Name of Dam: Camp Shenandoah Dam.
Location: Augusta County, State of Virginia
Inventory Number: VA 01515

PHASE I INSPECTION REPORT
NATIONAL DAM SAFETY PROGRAM.

Camp Shenandoah Dam (VA 01515).
Potomac River Basin. Augusta County,
State of Virginia. Phase I Inspection
Report.

SEPTEMBER 1978

PLATE 1

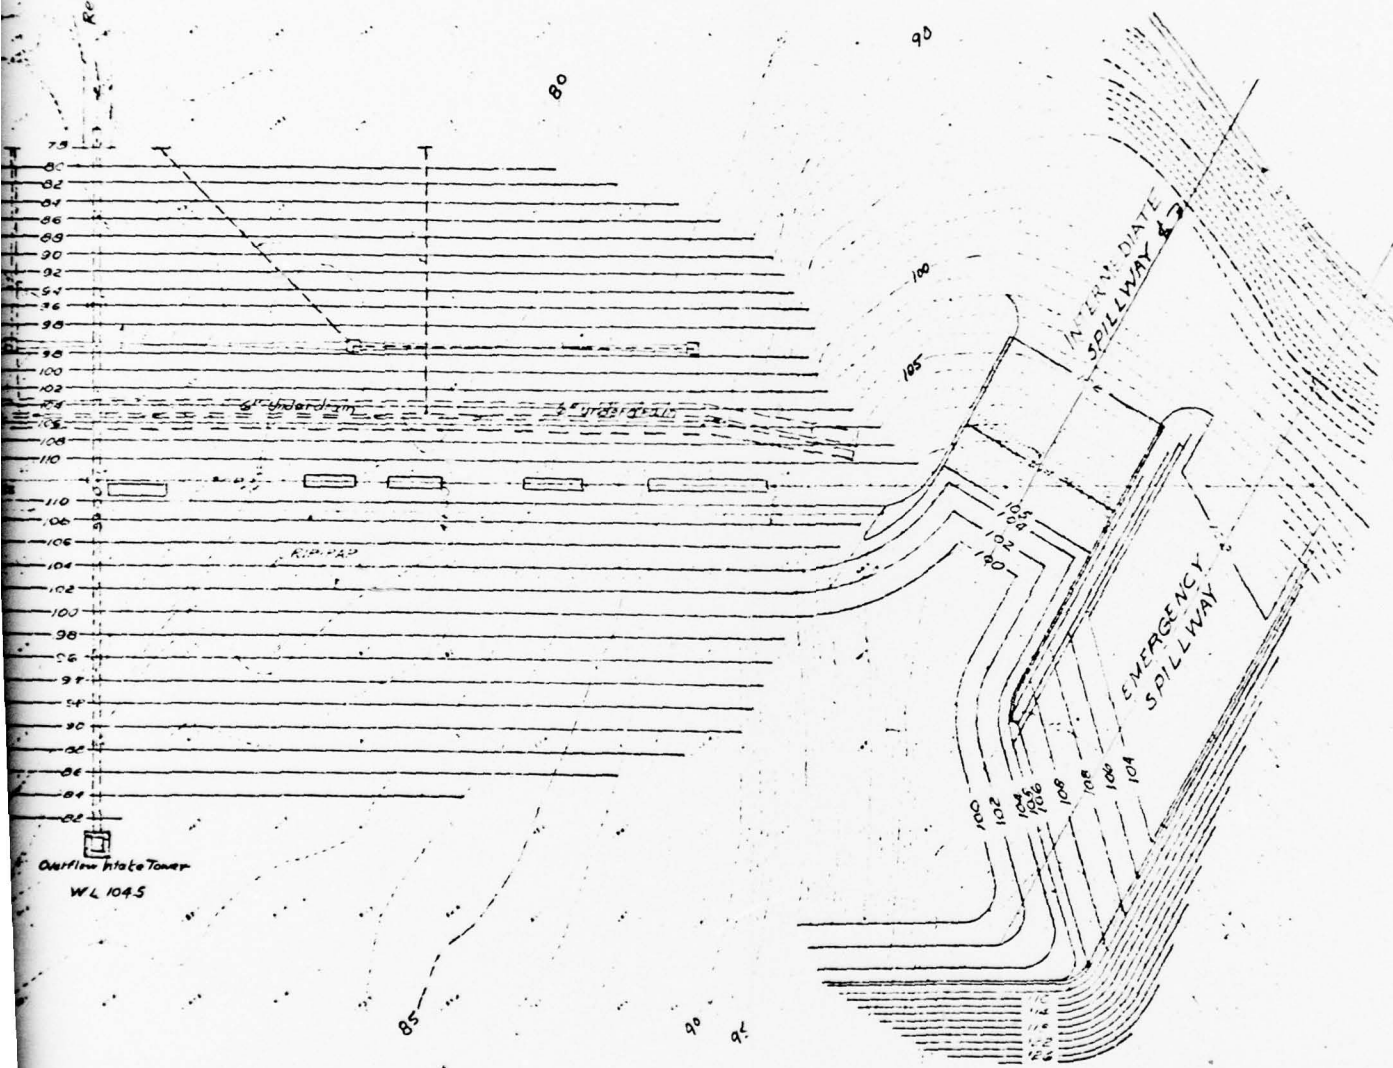
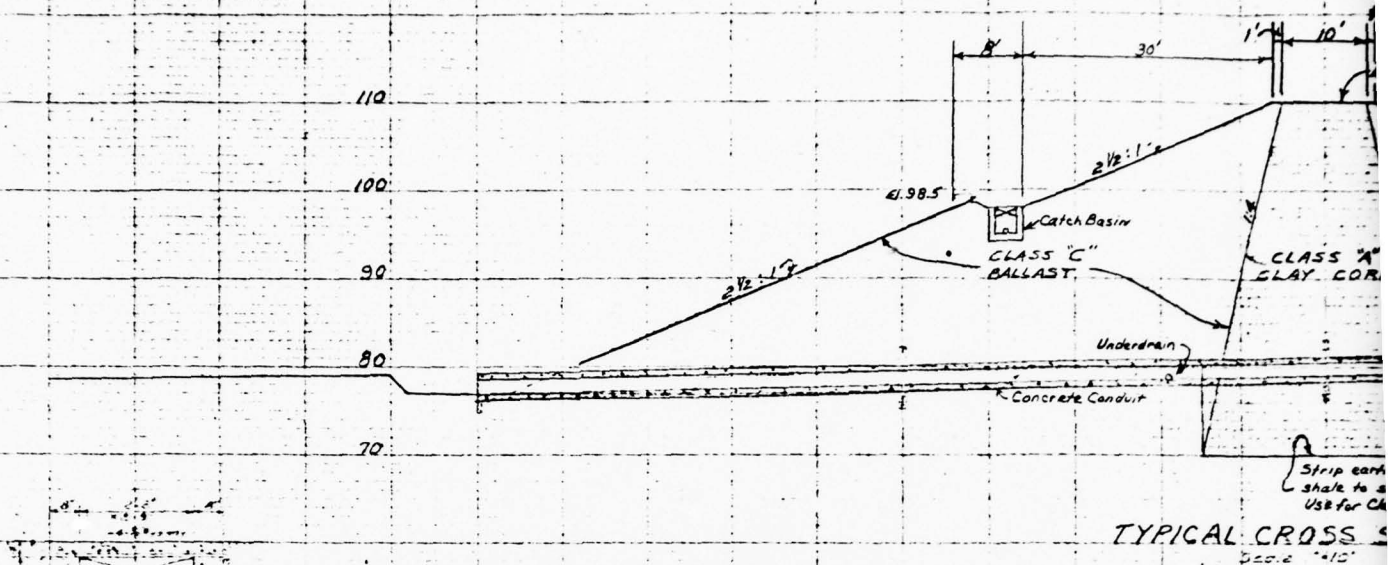
2.4.1 Design: The design plans were satisfactory for background information concerning the general construction features of the structure. The side-channel spillways were not constructed according to the original design. As-built drawings were unavailable.

The upstream and downstream embankments appear to be built on native soils. Test pits were dug along the alignment of the dam crest according to Plate 1; however, the soils encountered were not documented in the available plans.

ITEM	REMARKS
PLAN OF DAM	Plans of the dam were obtained from Camp Shenandoah. Significant differences were found between the plans and the actual construction. The available plan view of the dam is included in this report as Plate 1.
REGIONAL VICINITY MAP	The Location Plan is included.
CONSTRUCTION HISTORY	The available plans are dated 1949. Design by Wiley & Wilson, Consulting Engineers of Lynchburg and Richmond, Virginia for the Stonewall Jackson Council of the Boy Scouts of America, Staunton, Virginia.
TYPICAL SECTIONS OF DAM	Typical sections are included in the design plans. A typical section is included in this report as Plate 2.
HYDROLOGIC/HYDRAULIC DATA	Not Available
OUTLETS - PLAN AND	DETAILS are included in the design plans obtained from the camp.

- CAMP SHENANDOAH DAM, VIRGINIA -
SKETCH OF EXISTING SIDE CHANNEL SPILLWAYS

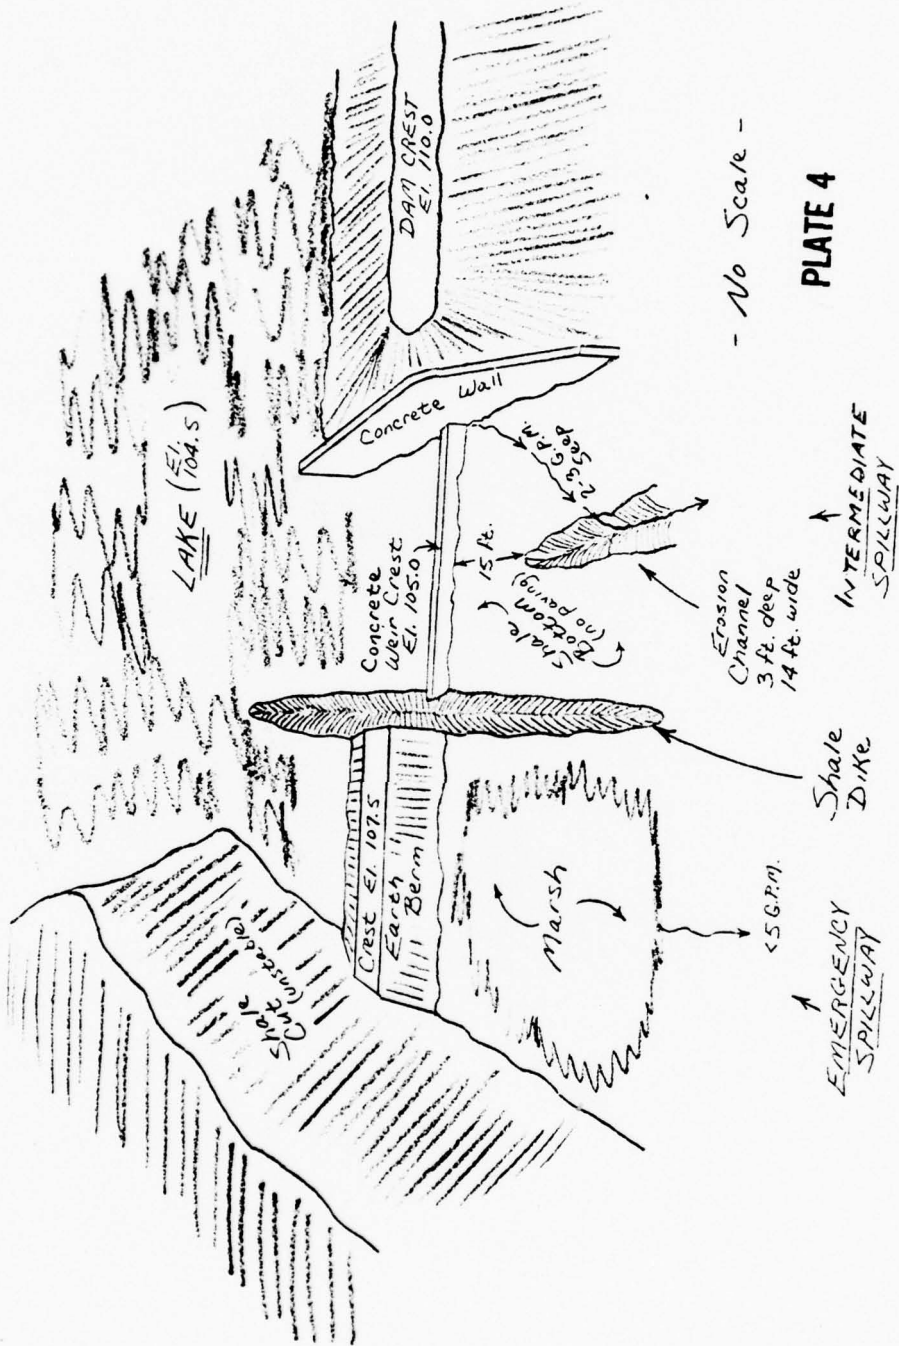
A plan view of the dam and typical sections are included in this report as Plates 1, 2 and 3, respectively. The spillways are not constructed as planned. Plate 4 is a sketch of the actual spillway features.

The approach and discharge channels of the two spillways are heavily overgrown and clogged with heavy debris (see Photos 3 and 4). A deep erosion channel in shale bedrock in the discharge channel of the intermediate spillway has rapidly progressed to within 15 feet of undercutting the concrete weir. The erosion is likely to continue, because the bedding orientation (strike N. 65° E., dip SE. 25°) is such that running water is essentially able to get under and lift the strata by the bedding planes.

The intermediate spillway was not constructed as indicated by the design details. The compacted clay liner with overlying concrete pavement is absent. It is unknown if the concrete weir extends to any appreciable depth forming a seepage barrier.

An approximate three to five g.p.m. clear seep is occurring under the north end of the concrete weir of the emergency spillway (see Photo 5). It is suspected that this clear seep is occurring through nearly vertical joints in the underlying shale which are oriented about in-line with the longitudinal axis of the spillway (joint strike N. 80° E., dip NW. 83°). This clear seep could undercut the weir.

A heavily tree covered berm constructed of clayey fill acts as the crest of the emergency spillway. The crest is at elevation 107.5 (assumed datum) (2.5 feet above the crest of the intermediate spillway). The design width across the crest of the berm was eight feet; actual width is a maximum of four to five feet. The width at the base is approximately 20 feet. A clear seep of less than five g.p.m., in the form of a marshy area, was observed in the discharge channel of the emergency spillway just below the berm (see Photo 6). Seepage may flow through the berm or through joints in the underlying shale.

- 5) Monitor the clear seep that is occurring below the north end of the concrete weir of the intermediate spillway to determine if undercutting might occur. If the potential exists, a compacted clay liner protected by riprap on the upstream side of the weir or similar abatement measure may be necessary.

- 6) A method of stopping the erosion in the intermediate spillway discharge channel is necessary. Backfilling the existing erosion channel and paving may be required to accomplish this.

- 7) A compacted clay liner on the upstream side of the berm in the emergency spillway may be necessary to prevent piping. This berm should also be widened and made more erosion resistant by riprap or other acceptable means.

PLATE 5

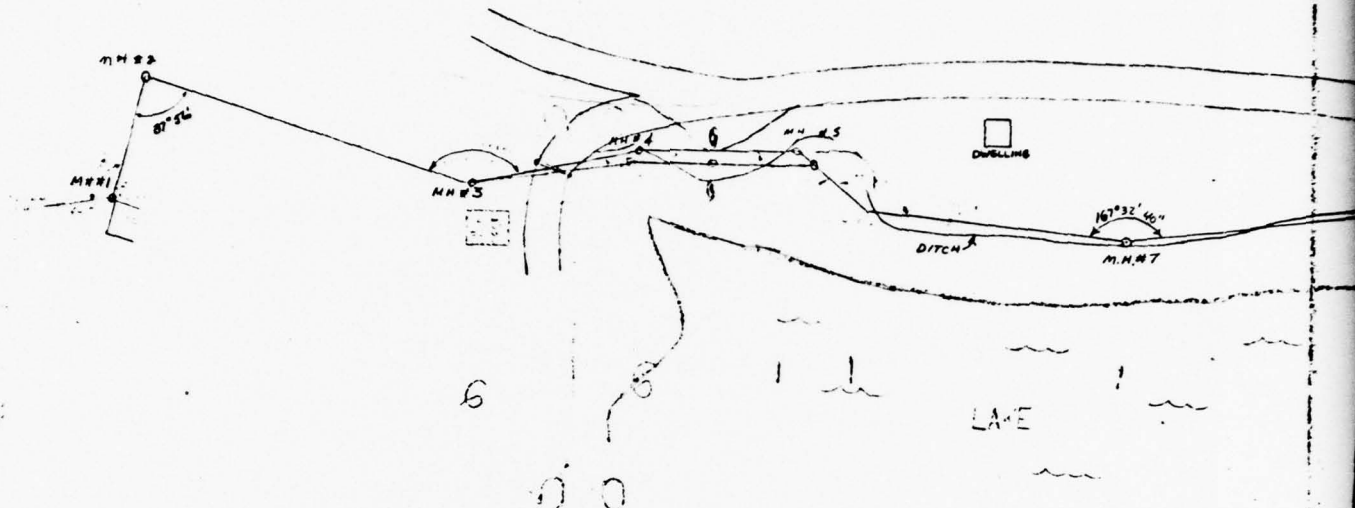
2.2 Construction: No construction data, reports, photos or other information were available for this evaluation. A 1976 Construction Plan for a sanitary sewer showed a culvert and manhole in the north end of the embankment (see Plate 5).

- 6.2.4 Post-Construction Changes: With the exception of the 18 inch culvert through the north end of the embankment, no alternations to the dam were apparent or reported since its construction.

POST-CONSTRUCTION ENGINEERING STUDIES AND REPORTS	Sanitary sewer line plans (1976) around north end of dam. Plans (borrowed from Camp Shenandoah) show a culvert that extends through northern dam embankment. The culvert should be eliminated.
---	--

- 4) Backfill the drainage ditch along the northern shoreline and remove the corrugated metal pipe which extends through the north abutment. Repair and reseed the area that has been eroded along the northern downstream toe of the dam.

PHOTO 1. Overflow Intake Tower

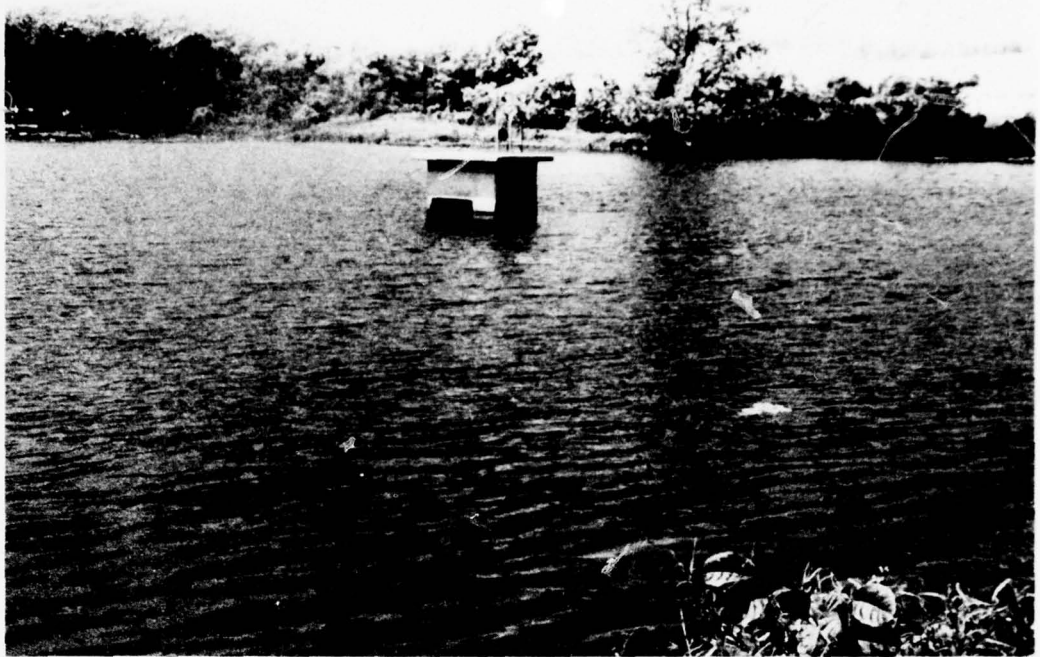
- 3.1.3 Appurtenant Structures: The inlet structure, outlet pipe and emergency gate are generally in good condition. However, the mesh of the trash rack (see Photo 1) on the intake tower is small (three-fourths of an inch) and could easily clog. The ladder for access to the tower is rusted through in a few places.

Approximately one-half of the intake tower trash rack was clogged with small debris at the time of the inspection.

- 8) Riprap around the outlet conduit and immediate discharge channel.
- 9) Replace the intake tower trash rack (three-fourths of an inch mesh) with larger mesh or a bar screen. Repair or replace the intake tower access ladder.
